Addendum No. 001

Subject: Mechanical Plant Replacement Bid Package
Mechanical
SDP Contract No. B-045 (c) of 2017/18

Location: Arts Academy at Benjamin Rush
11081 Knights Road
Philadelphia, Pennsylvania 19154

DRAWING NO.
MD100

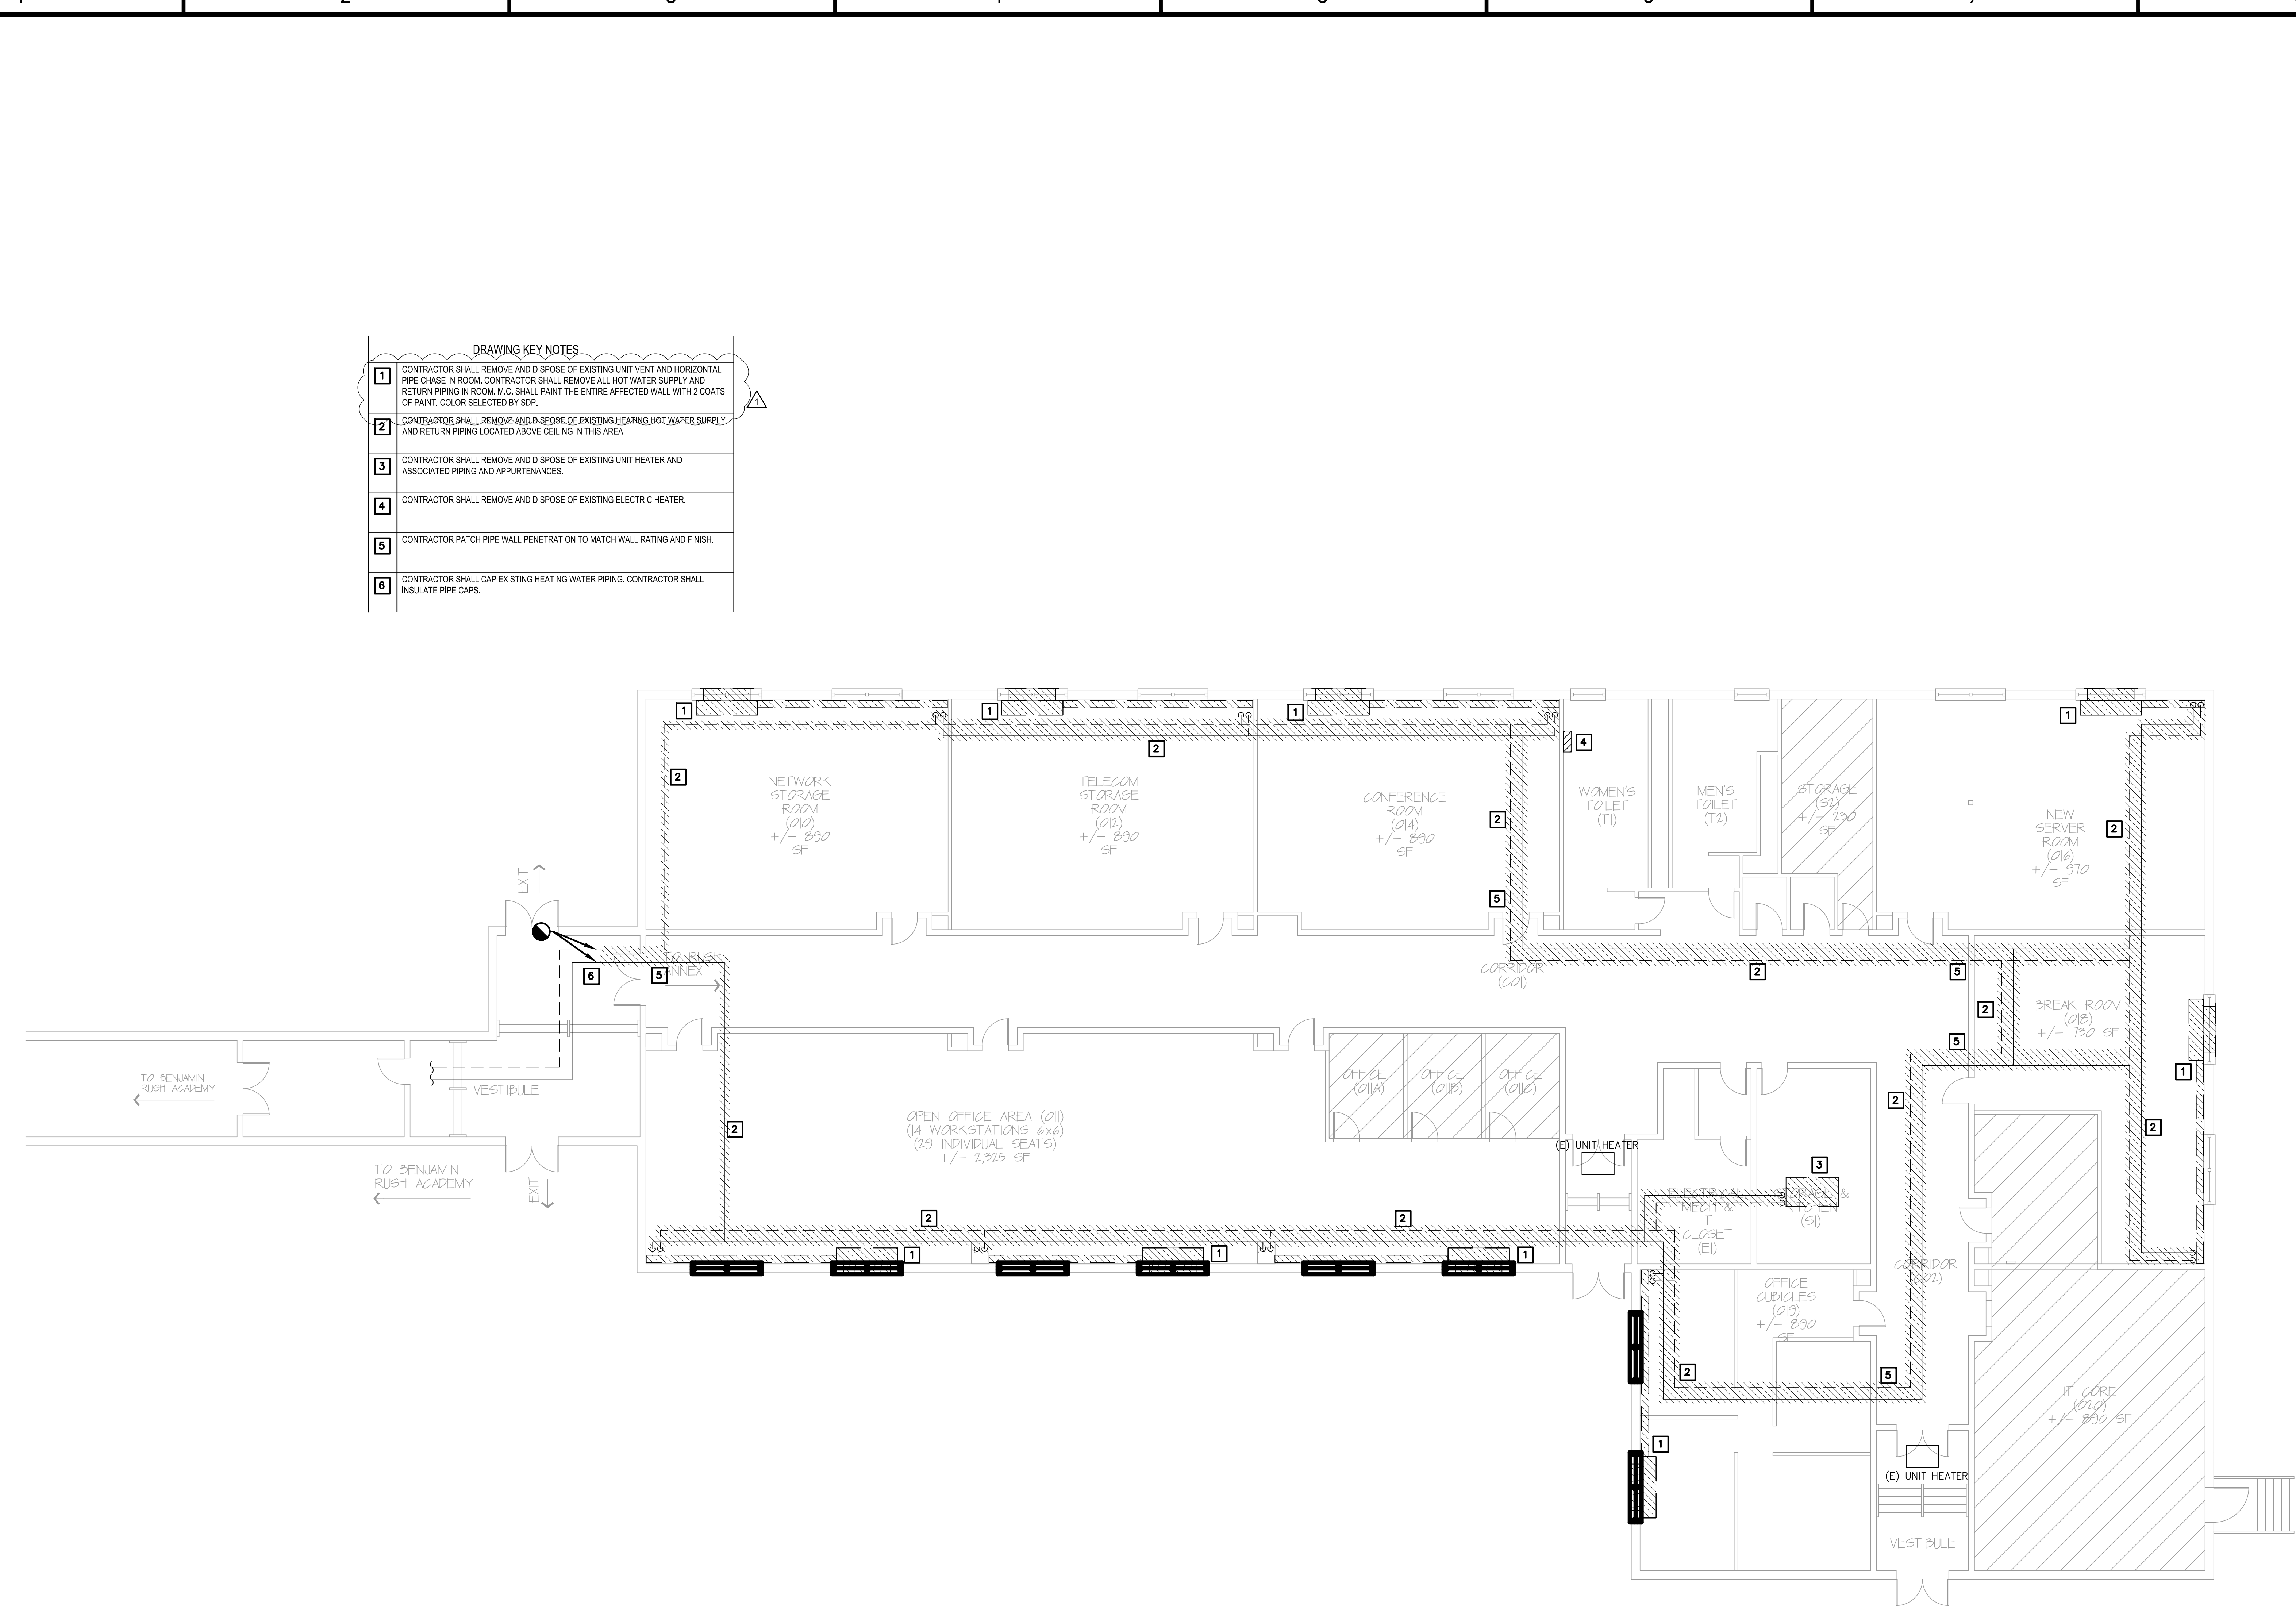
- 2.1.3** Drawing revision M001 – Revised Drawing Changed Drawing Number System legend.
- 2.1.4** Drawing revision MD100 – Revised Drawing Key Note 1 to include Mechanical Contractor shall paint the entire affected wall with 2 coats of paint.

3.1.5 Please confirm that the mechanical contractor is responsible to paint walls to match in areas where equipment/piping is removed.

- Refer to 2.1.4 above.

- DRAWING KEY NOTES**
- 1** CONTRACTOR SHALL REMOVE AND DISPOSE OF EXISTING UNIT VENT AND HORIZONTAL PIPE CHASE IN ROOM. CONTRACTOR SHALL REMOVE ALL HOT WATER SUPPLY AND RETURN PIPING IN ROOM. M.C. SHALL PAINT THE ENTIRE AFFECTED WALL WITH 2 COATS OF PAINT. COLOR SELECTED BY SDP.
 - 2** CONTRACTOR SHALL REMOVE AND DISPOSE OF EXISTING HEATING HOT WATER SURPLY AND RETURN PIPING LOCATED ABOVE CEILING IN THIS AREA.
 - 3** CONTRACTOR SHALL REMOVE AND DISPOSE OF EXISTING UNIT HEATER AND ASSOCIATED PIPING AND APPURTENANCES.
 - 4** CONTRACTOR SHALL REMOVE AND DISPOSE OF EXISTING ELECTRIC HEATER.
 - 5** CONTRACTOR PATCH PIPE WALL PENETRATION TO MATCH WALL RATING AND FINISH.
 - 6** CONTRACTOR SHALL CAP EXISTING HEATING WATER PIPING. CONTRACTOR SHALL INSULATE PIPE CAPS.

DRAWING NO.
M100

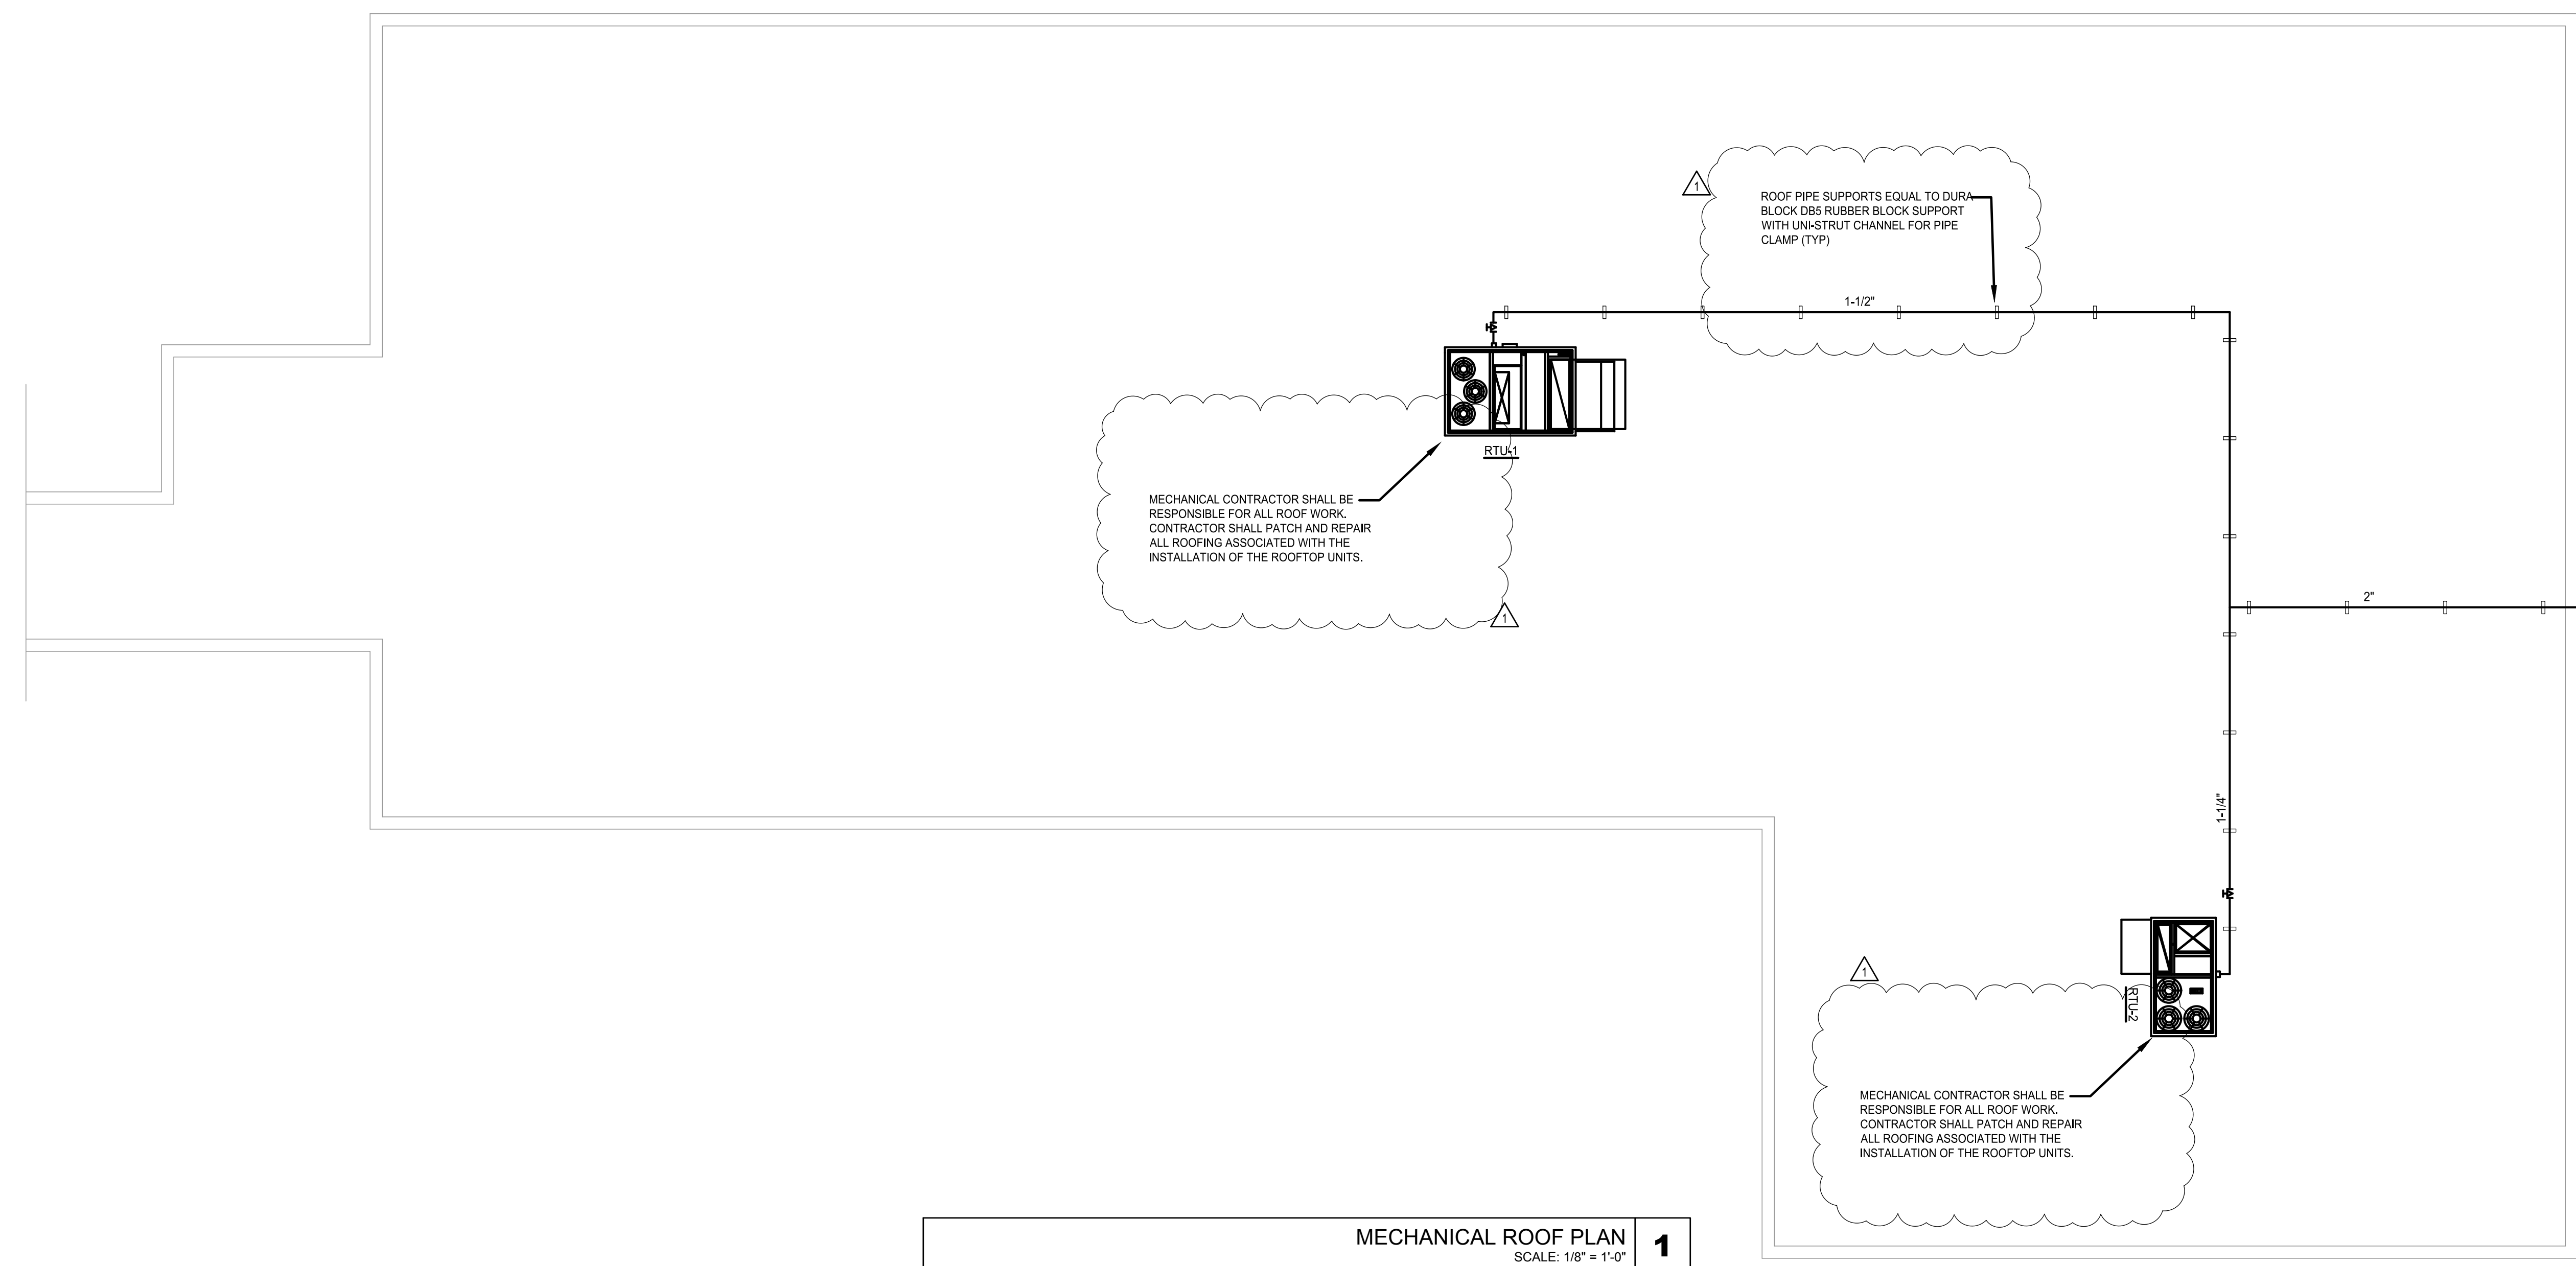
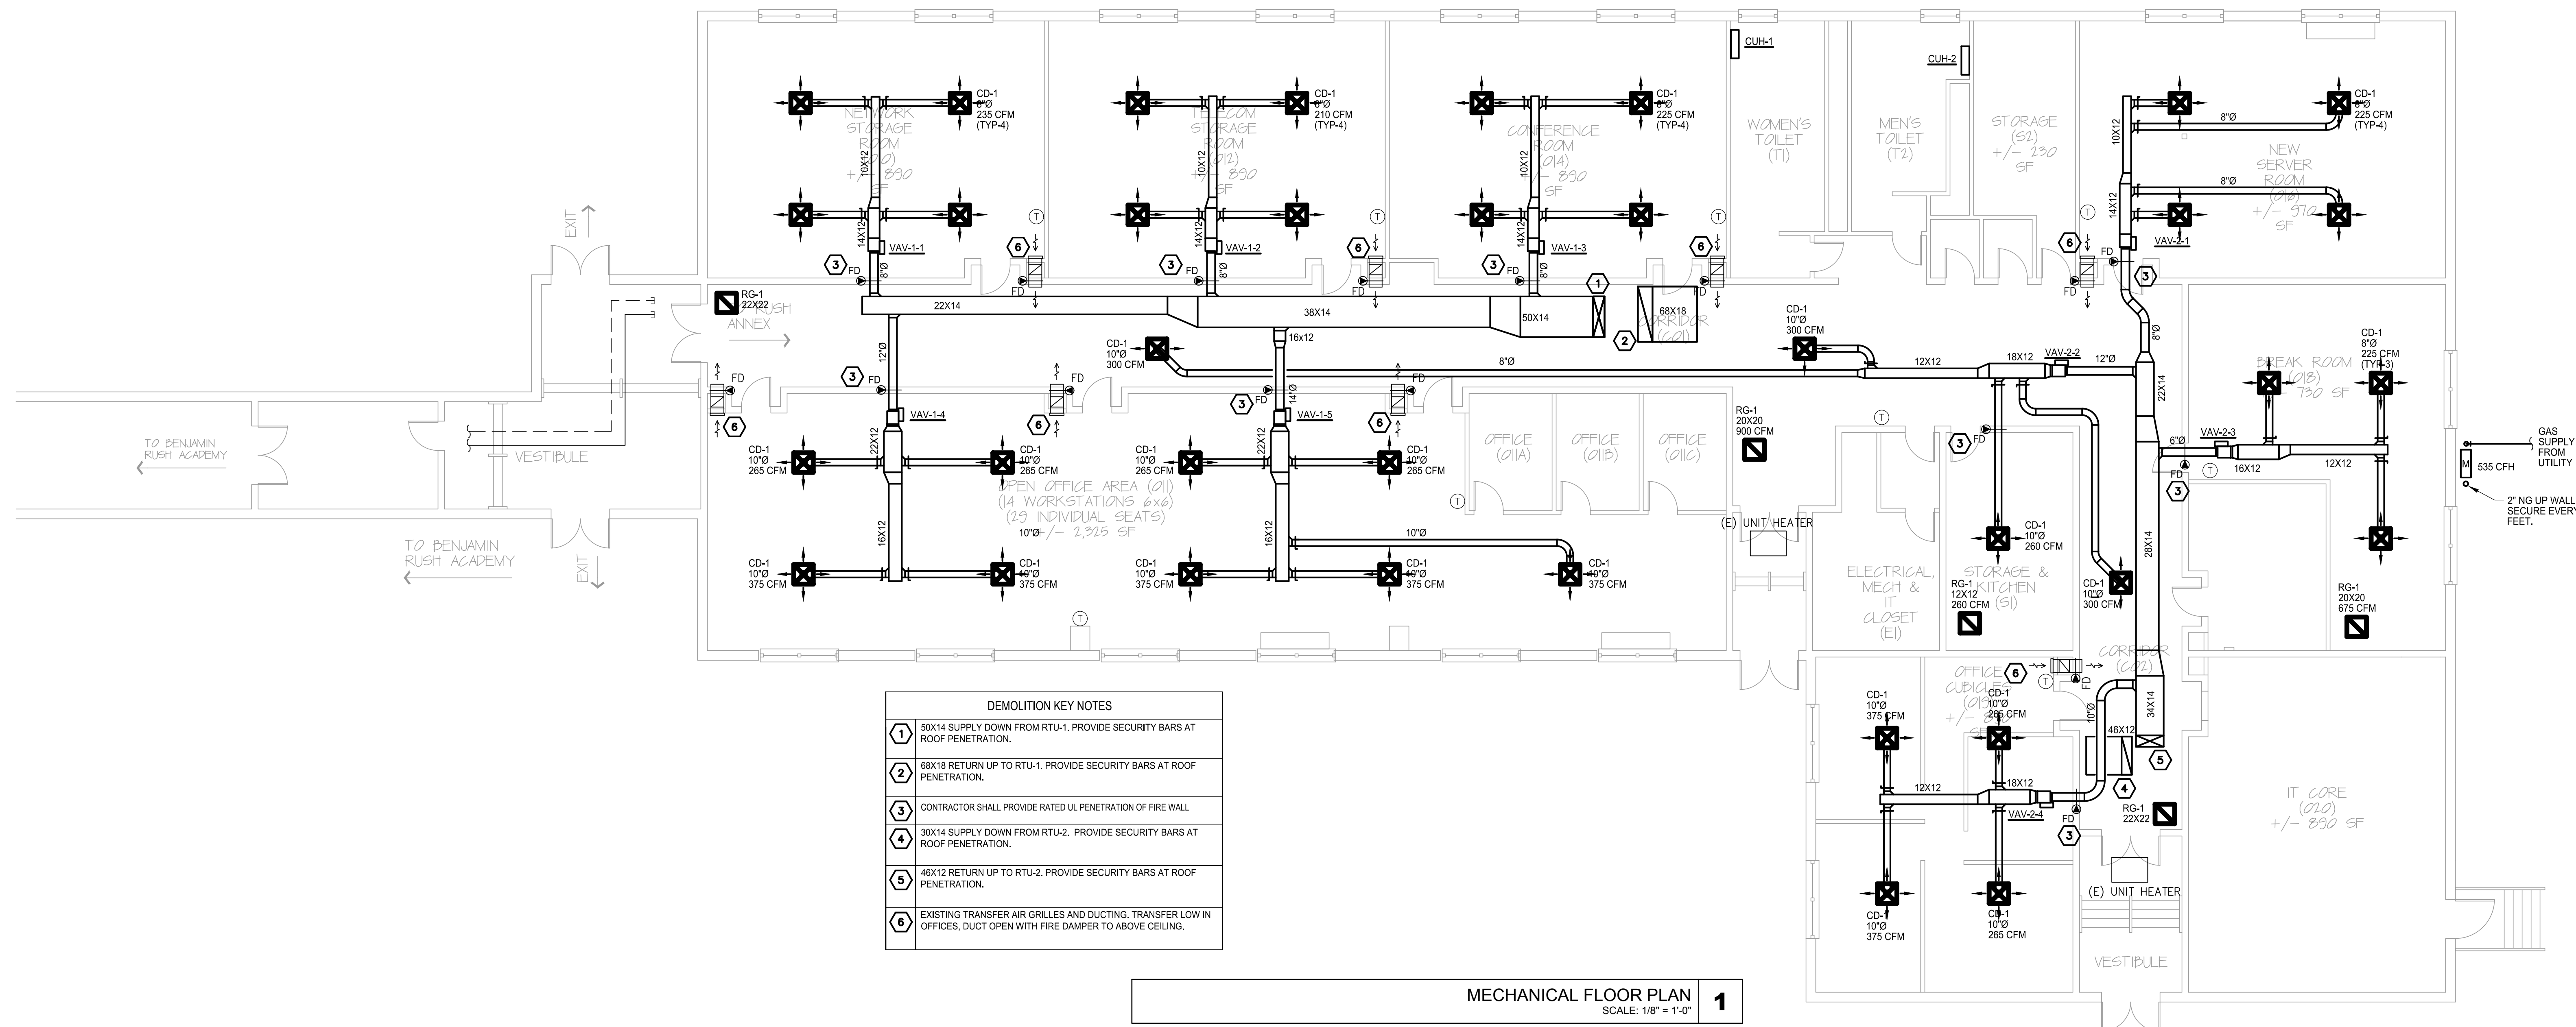
- 2.1.5** Drawing revision M100 – Added noting for M.C. responsibility for all roof work associated with the installation of the roof curbs and rooftop units. Added noting for pipe roof supports.
